Access Compliance Report

Public Rights-of-Way

(Curb Ramps)

Intersection ID: 6068	Main Street: CATHEY_RD	Cross Street: COULWOOD_DR	Location:	N
ADA ID: 31506547195F	Ramp Type: Perp	Initial Pass/Fail: Fail	Overall Compliance: No	Severity Score: 8.75
Codes/Mitigation Info/Possible Solution		Field Measurements/Component Compliance

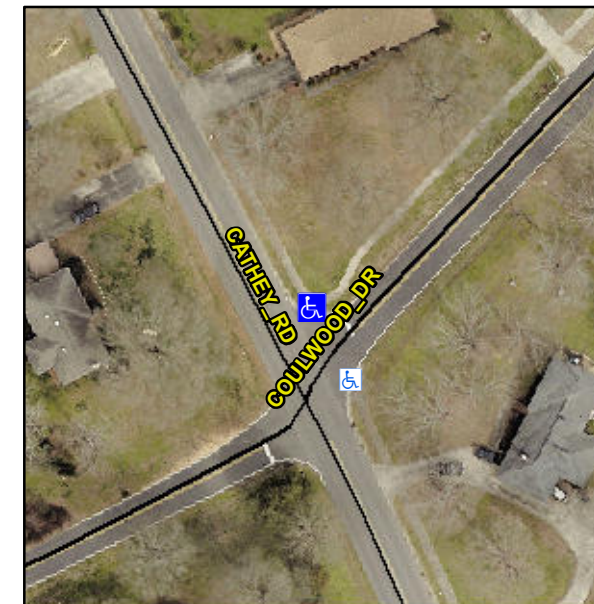
Not Found, R304.5.1

Compliance	Description	Data	Compliance	Description	Data
N/A	Ramp Length (in)	49.0	Yes	Ramp Slope (%)	7.3
No	Ramp Width (in)	47.5	Yes	Ramp XSlope (%)	0.6
N/A	Flare Type LT	N/A	N/A	Flare Type RT	N/A
N/A	Flare Slope LT (%)	N/A	N/A	Flare Slope RT (%)	N/A
N/A	Flare Traversable LT?	N/A	N/A	Flare Traversable RT?	N/A
N/A	Landing Length (in)	N/A	N/A	DWS Provided?	N/A
N/A	Landing Width (in)	N/A	N/A	DWS Contrast?	N/A
N/A	Landing Slope (%)	N/A	N/A	DWS Length (in)	N/A
N/A	Landing X Slope (%)	N/A	N/A	DWS Full Width?	N/A
N/A	Landing Curb? (Y/N)	N/A	N/A	DWS Offset (in)	N/A
N/A	Shared Landing?	N/A			
N/A	Gutter Ponding?	N/A	N/A	Gutter Slope (%)	N/A
N/A	Gutter Lip Ht (in)	N/A	N/A	Gutter X Slope (%)	N/A
N/A	Painted X Walk1?	No	N/A	Painted X Walk2?	N/A
	X Walk 1 Direction	To S		X Walk 2 Direction	N/A
N/A	X Walk 1 Width (in)	N/A	N/A	X Walk 2 Width (in)	N/A
	X Walk 1 Slope (%)	5.6		X Walk 2 Slope (%)	N/A
	X Walk 1 X Slope (%)	0.4		X Walk 2 X Slope (%)	N/A

Remove & Replace Entire Ramp.
